## **Product Change Notification - 2020/10**

Product Line:	Plugs	Part No:	NP2RX-AU- SILENT
Piece Part:	BG Insert RX-AU-SILENT	Part No:	8800461
Engineering Change Notification:	-	Date:	04.03.2020
Comments:	Solder to guarantee contact		
A.C	NP2RX-AU-SILENT		
Affected products:	NF2KA-AU-SILENT		
First Shipment of Modified Product:	M23

ECN #10-2020

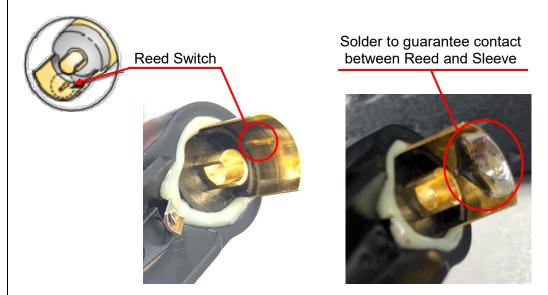
All connectors featuring a Reed switch have to pass a 100% electric quality test before shipping. This test showed partially right angle silentPLUGs whose Reed contact had no contact to the sleeve solder area. To guarantee contact, solder was added in this area. Due to the 100% quality test which is performed with all products featuring the Reed switch, there are no defective products on the market.
